PRE-CONSTRUCTION TREE EVALUATION FOR LARK STREET CORRIDOR IMPROVEMENTS

Jay Lavigne, City Arborist
ISA Certified Arborist and Municipal Specialist, NE-7257 AM
Massachusetts Certified Arborist MCA-2534
June 1, 2023

Tree Lilac at 284 Lark Street. Very Close to utility pole and obstructing site lines to signage.

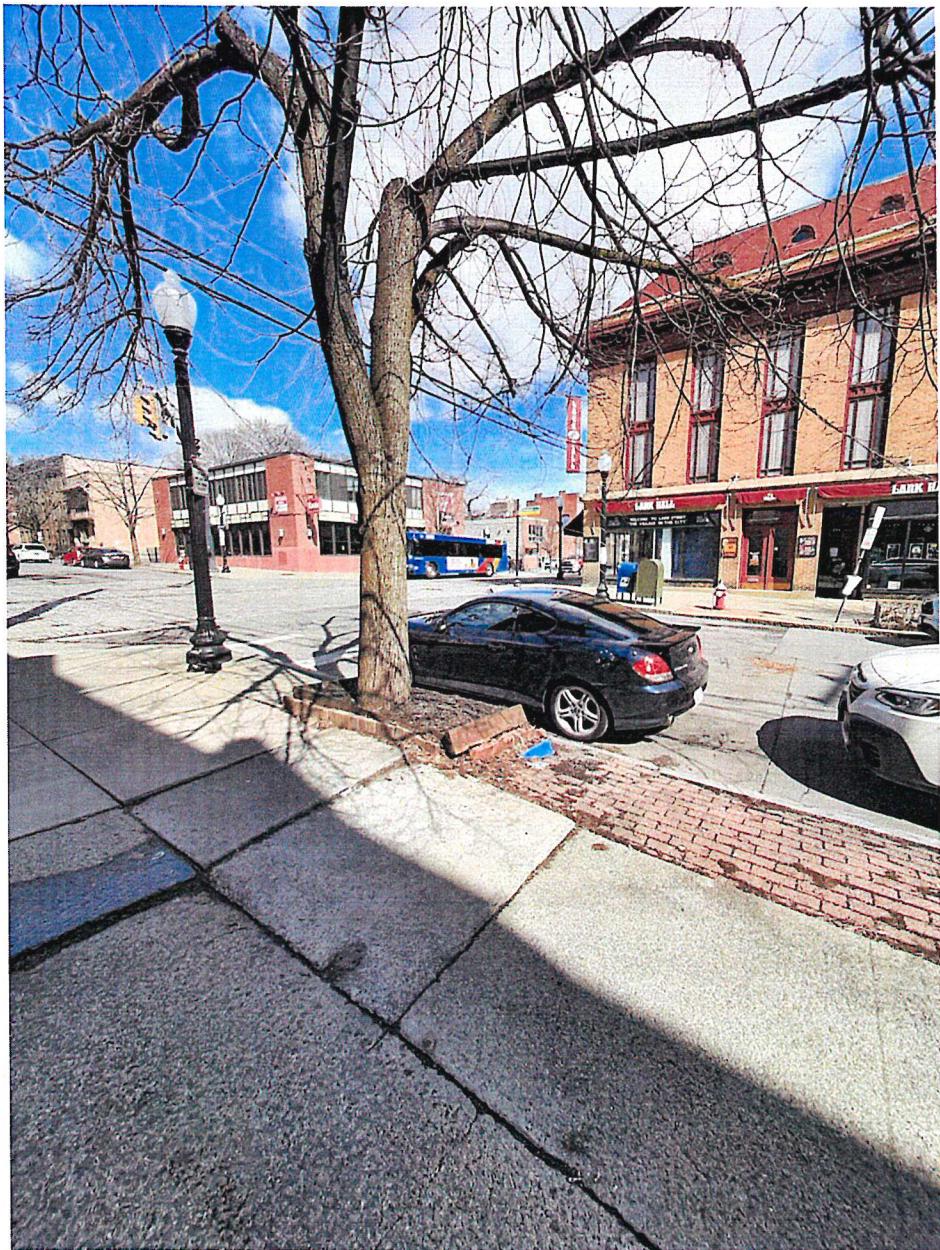
Topped little leaf linden with heaved Sidewalks around it at 358 Hudson Avenue. Wrong tree in the wrong place.

Water Valve Shut off in Tree Well at 254 Lark. Originally proposed as a planting site, if this shut off is operational, then the site should be abandoned and restored to sidewalk.

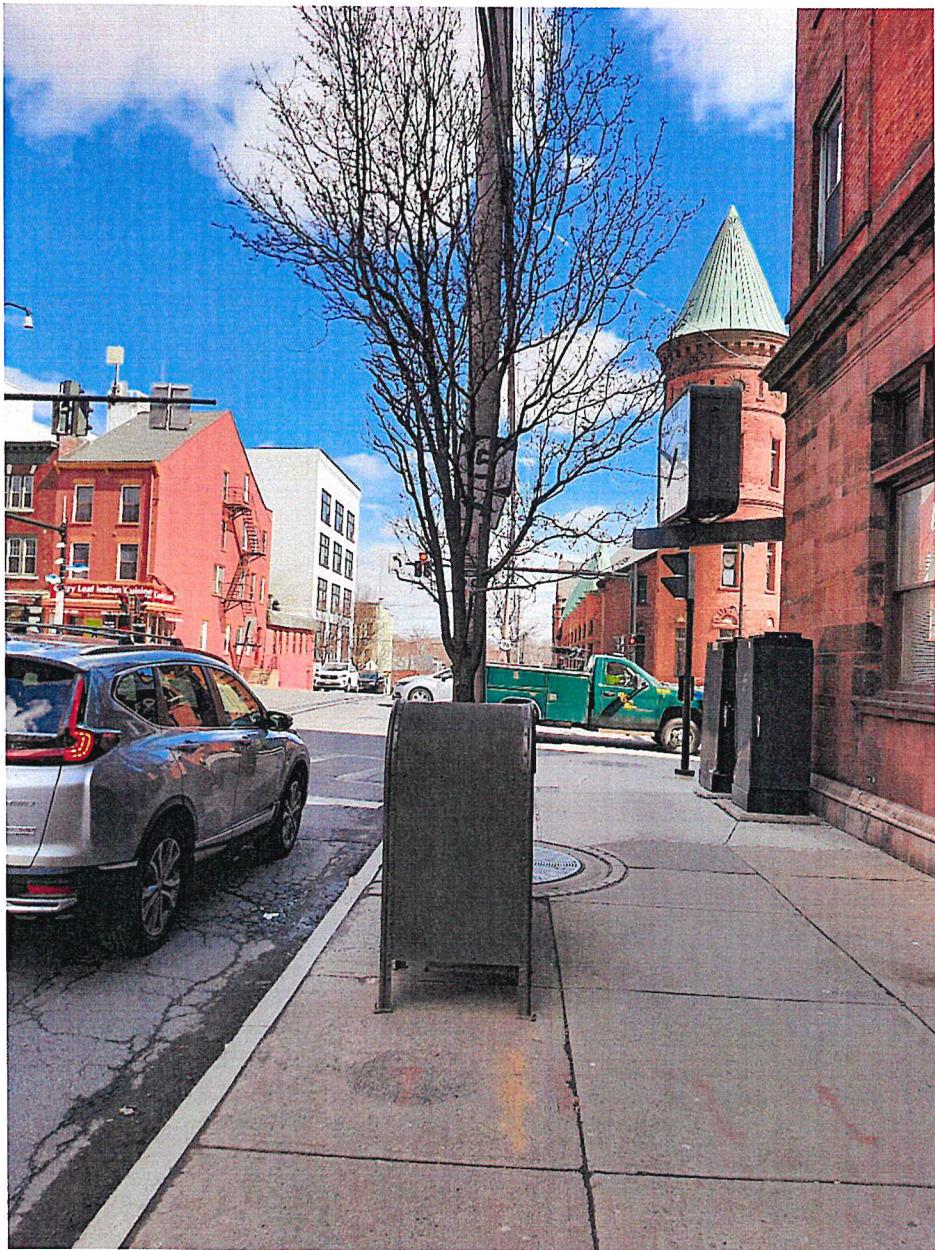
Callery Pear on Lark Street Adjacent to 196 Washington Avenue, under utilities and wedged between mail box and utility pole, blocking signage.

Stunted red oaks at 219 Lark

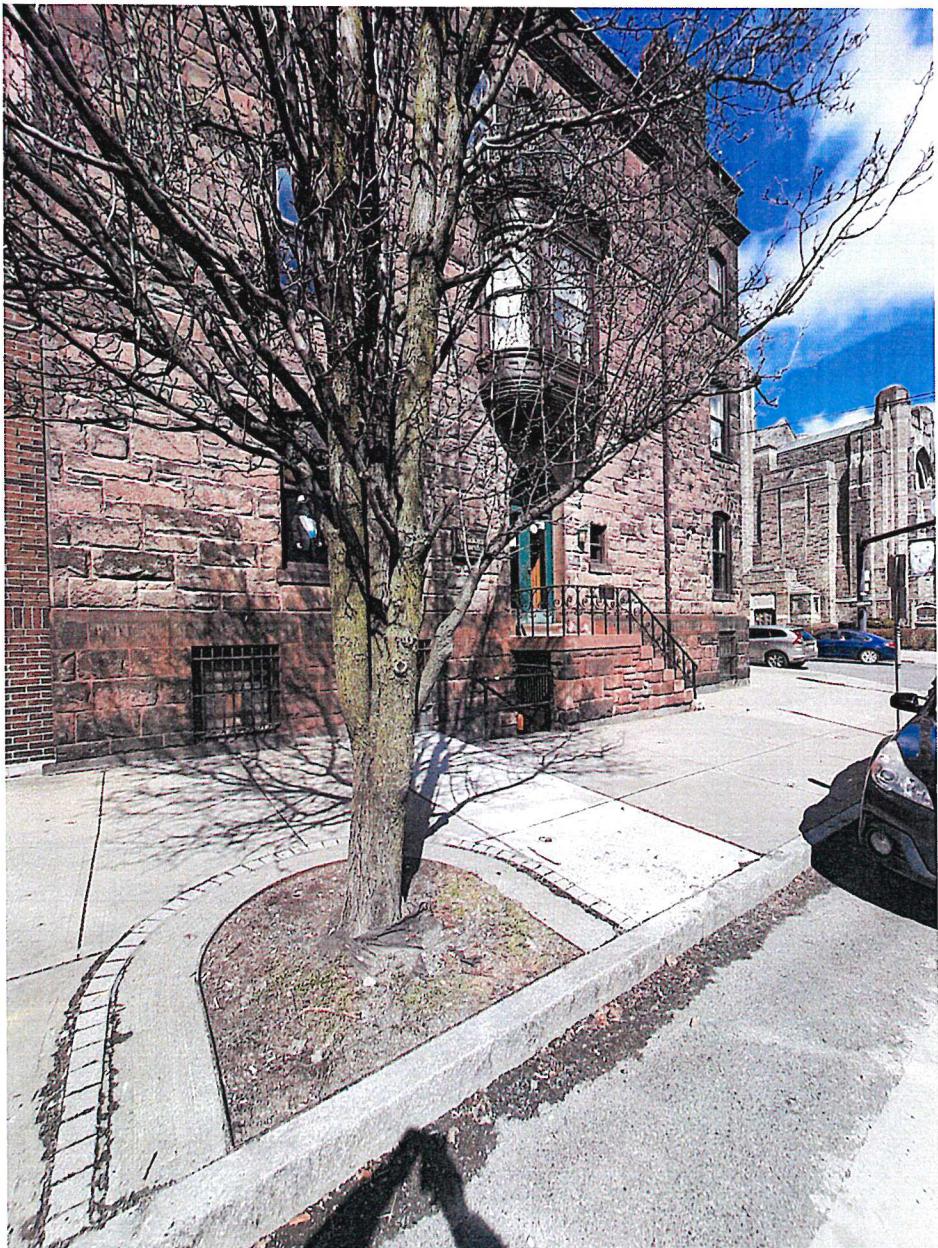
Low Branching Callery Pear on Lark Street Adjacent to 204 Lancaster Street

Topped and reaching Callery Pear at 267 Lark Street.

Callery Pear on Lark Street at 439 Madison Avenue, obstructing site lines to signage at corner/bus stop.
